October 17, 2008
BVY 08-070

**Subject: Vermont Yankee Nuclear Power Station
License No. DPR-28 (Docket No. 50-271)
Technical Specifications Proposed Change No. 273, Supplement 3,
Response to Additional RAI Related to Degraded Grid Protection**

Technical Specification Proposed Change No. 273, Supplement 3
Vermont Yankee Nuclear Power Station
Response to Request For Additional Information

ECCS Test Results - Strip Chart Recorder

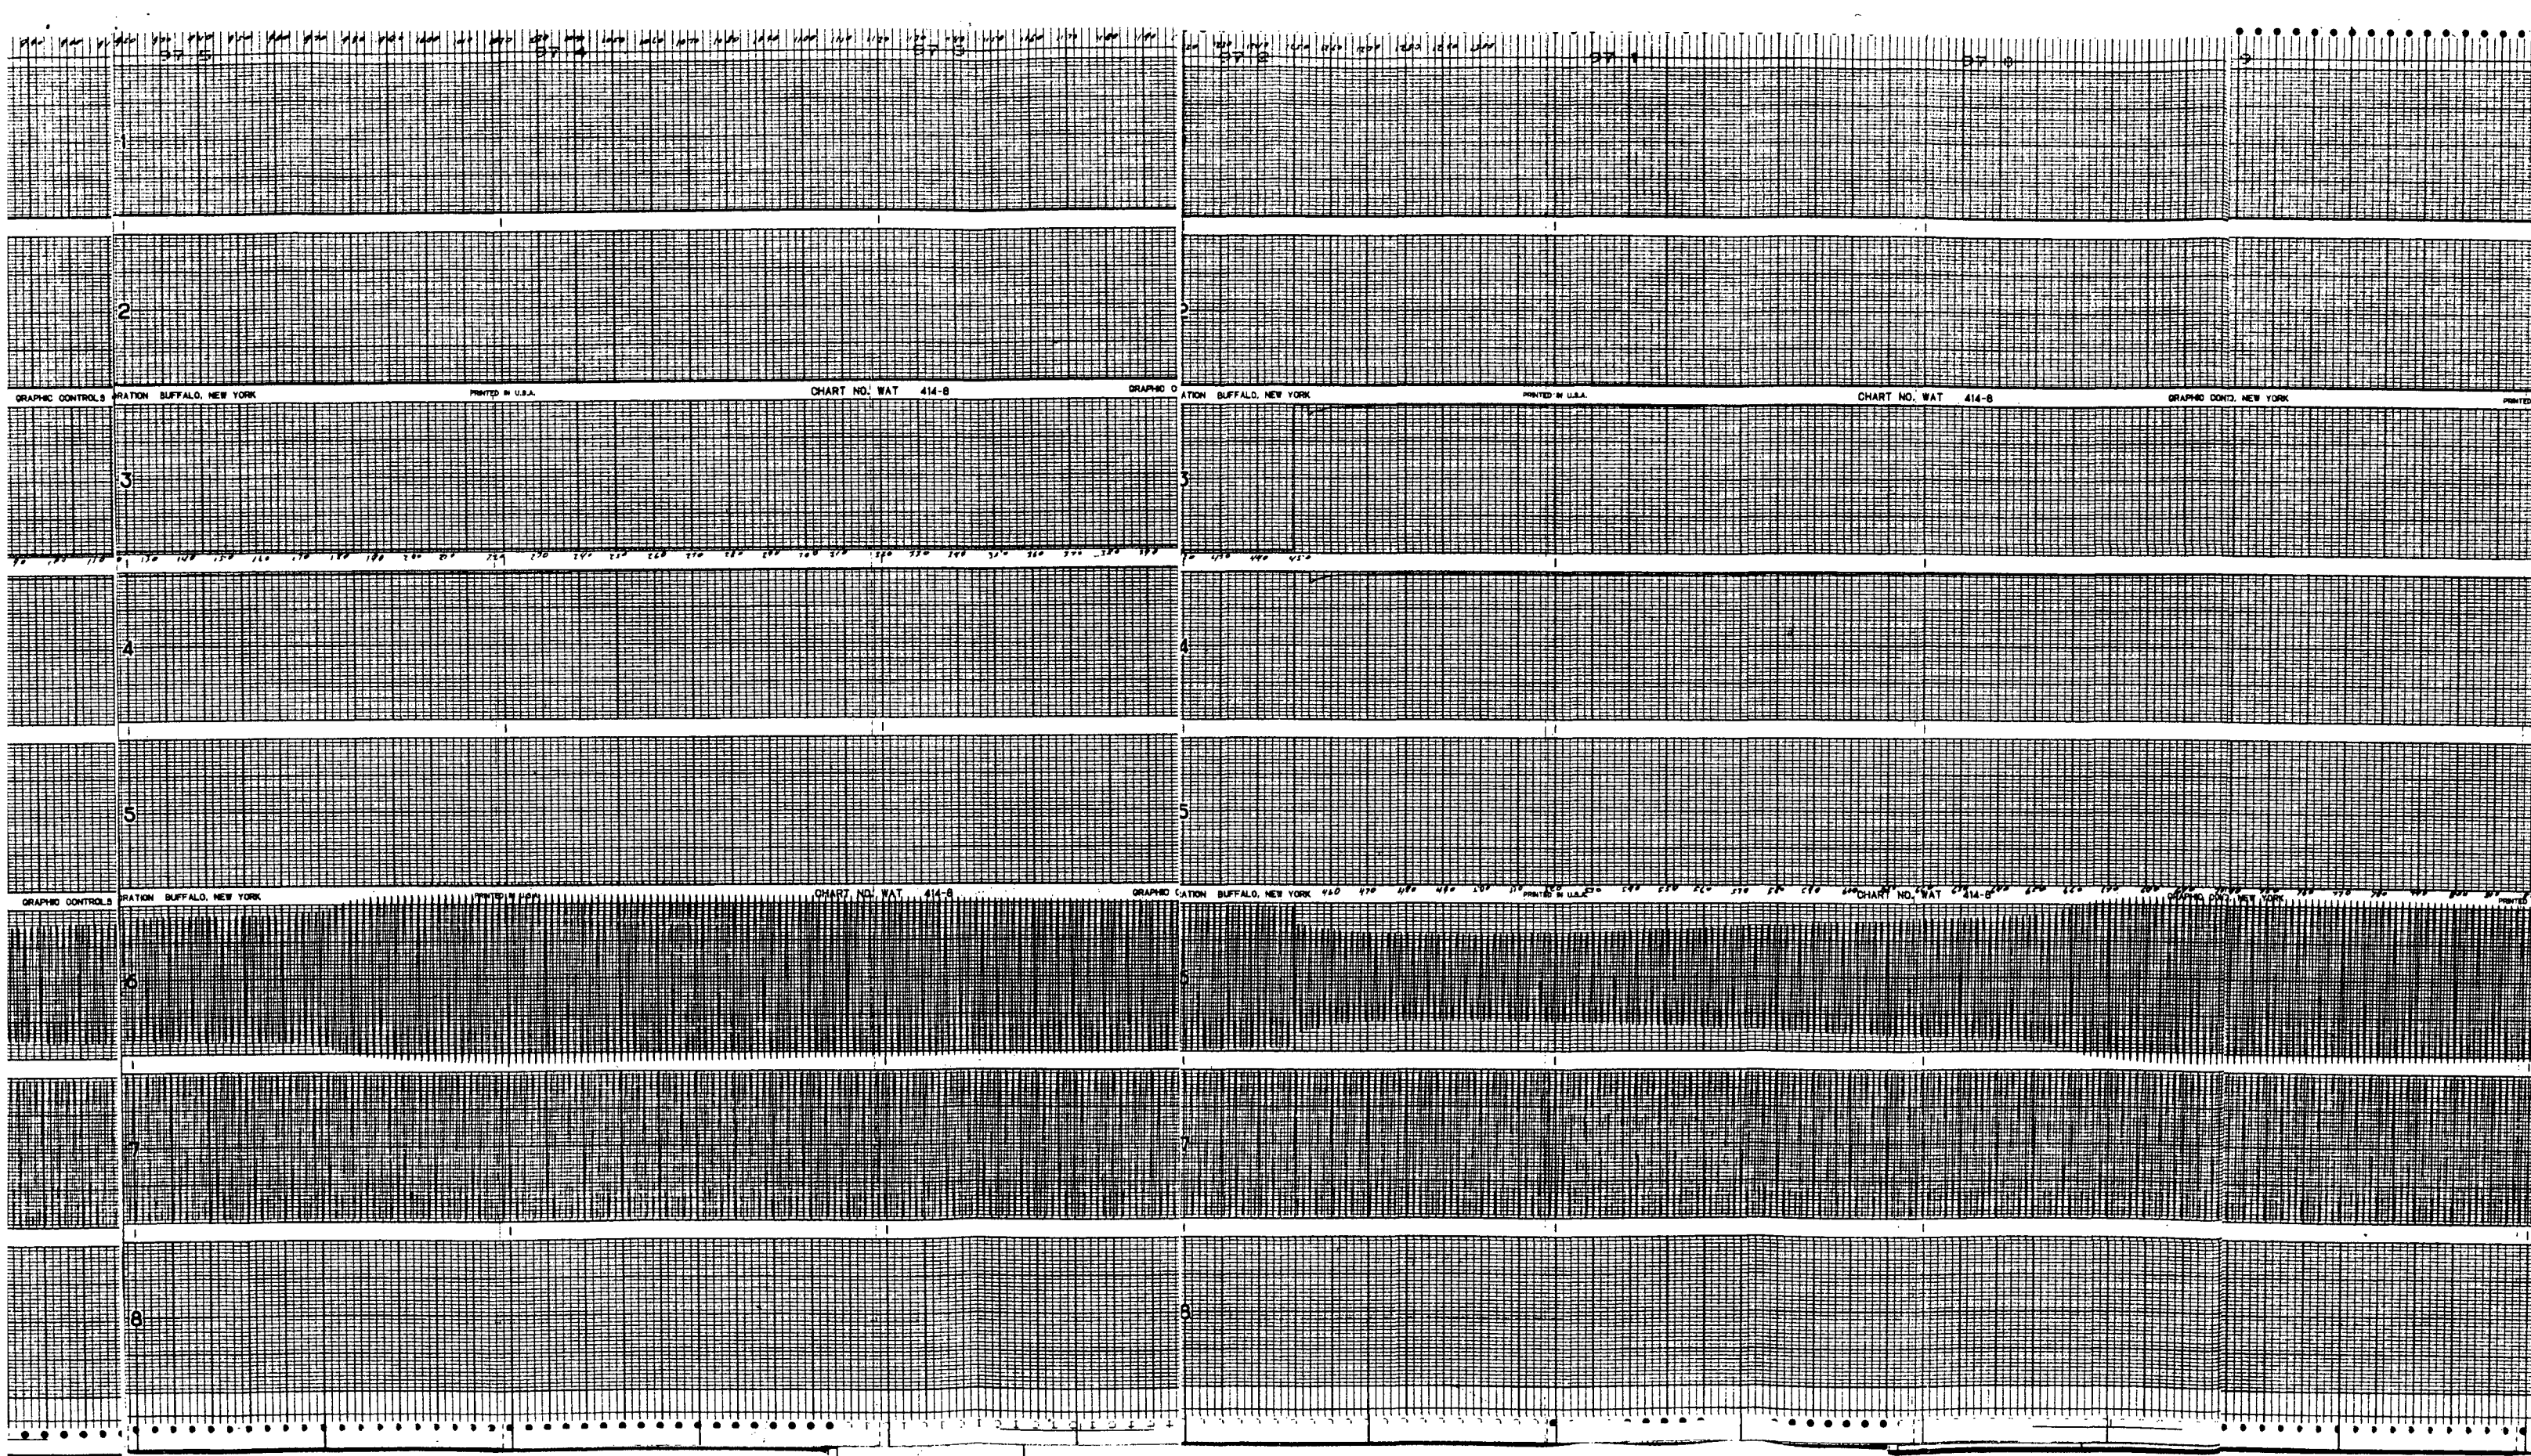
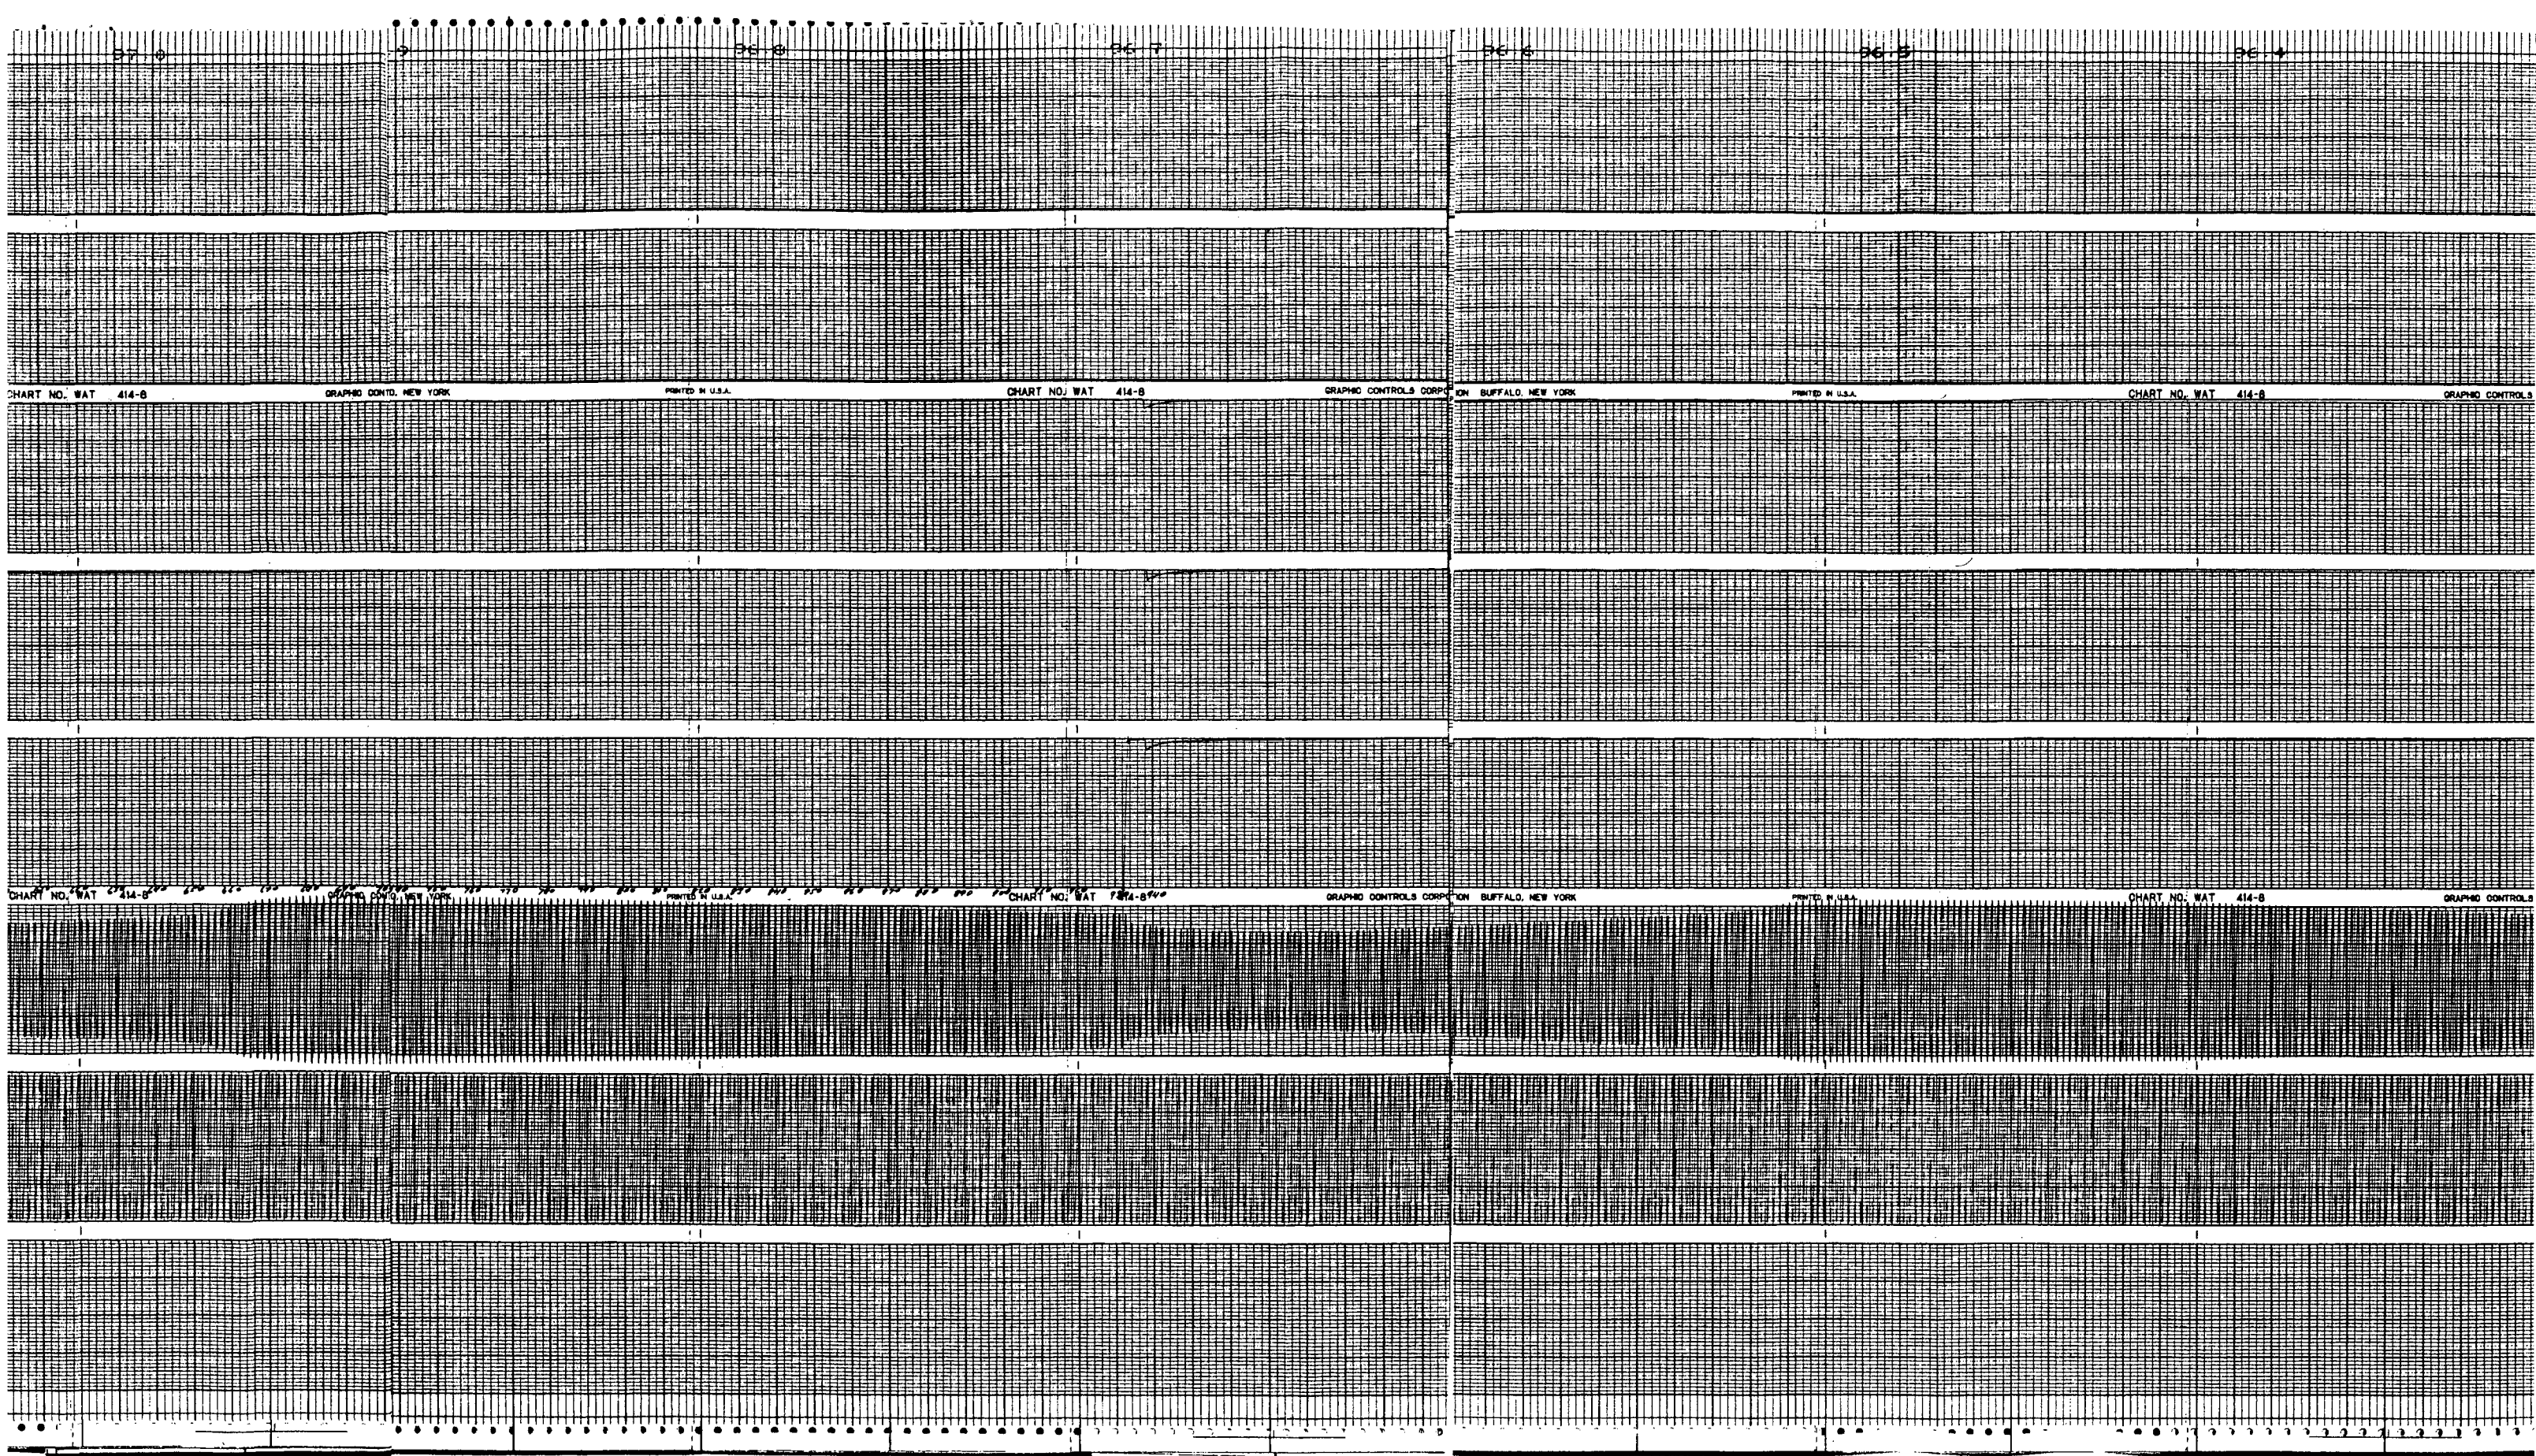
Provide a copy of the document which confirms that the transient voltage dip to 2538 V lasts less than 0.1 seconds and the voltage quickly recovers to the analyzed value of 70% of the motor rated voltage. Explain how the 70% of rated motor voltage is 3400 volts.

Each refueling outage, Vermont Yankee (VY) performs OP 4100, Integrated ECCS Test, which simulates a loss of offsite power and demonstrates that accident loads automatically start on the emergency diesel generators (EDG) in the required time. This test satisfies Technical Specification (TS) Surveillance 4.10.A.1.b.

This test was last performed during the spring 2007 refueling outage. Strip chart recordings of 4160 V bus voltage, and breaker operation for each automatically started ECCS motor are obtained as part of the test. These strip charts are used to document that the large motors start within the required time (see Attachment 2).

Examination of the strip chart recordings for EDG-B and 4160 V Bus 3 from the 2007 Integrated ECCS Test indicates that the worst case voltage dip during EDG voltage transient occurs when the second RHR pump motor starts. This larger voltage dip is created because, when the breaker for this load closes, the EDG voltage regulator is adjusting bus voltage toward nominal values after the voltage overshoot from the start of the previous large load and because the EDG is already carrying load from the 480 V system, the service water pump and the previously started RHR pump.

Examination of the voltage for the start of the 2nd RHR pump indicates the following:

Event	Strip Chart Reference	Strip Chart Units (Voltage)	Bus Voltage	Motor Voltage (%)
Initial Voltage	0	19	4200	105
Bus Voltage at Motor Start	450	19	4200	105
Minimum Voltage	490	11.5	2542	64
Min Voltage + 0.1 sec	500	11.5	2542	64
Min Voltage + 0.2 sec	510	12	2653	66
Min Voltage + 0.3 sec	520	12	2653	66
Min Voltage + 0.4 sec	530	12	2653	66
Min Voltage + 0.5 sec	540	12.5	2763	69
Min Voltage + 0.6 sec	550	13	2874	72
Min Voltage + 0.7 sec	560	13.5	2984	75
Min Voltage + 0.8 sec	570	14	3095	77
Min Voltage + 0.9 sec	580	14.5	3205	80
Min Voltage + 1.0 sec	590	15	3316	83

Each 10 units on the strip chart recording represent a time of 0.1 seconds. Minimum voltage shown occurs at strip chart reference 490 and lasts approximately 0.1 seconds.

EDG voltage continues to recover to nominal voltage within the next 0.7 seconds. The 700 hp CS pump motor starts successfully on the next load step with minimum voltage dip to 72% of rated motor voltage.

70% of rated motor voltage is 2800 volts not the 3400 volts previously stated.
